TECHNICAL INFORMATION

65403

- Subject** ▶ Change of Hex. Socket Head Bolt M4x30
- For Models** ▶ 6953, BTD150, BTW150, BTW151
- Country** ▶ All countries
- Description** ▶ Hex. Socket Head Bolt M4x30 (Part No. 922156-8) has been changed to Hex. Socket Head Bolt (Part No. 266295-7)

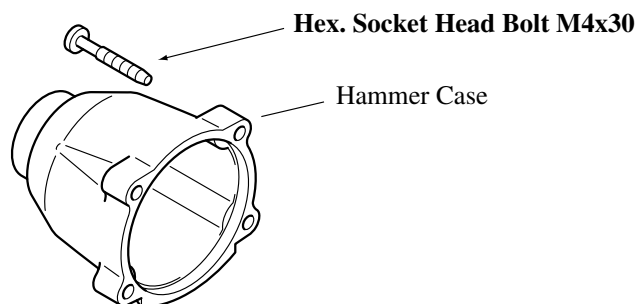
▶ Current	▶ New
	<p>Adhesive has been added. (Orange color)</p> <p>5.0 mm</p>

Item No.	Current part		Q'ty	I/C	New part		Q'ty	Note
See below.	Hex. Socket Head Bolt M4x30 922156-8		4	←	Hex. Socket Head Bolt M4x30 266295-7		4

The arrow ← means that the new part can be substituted for the current.
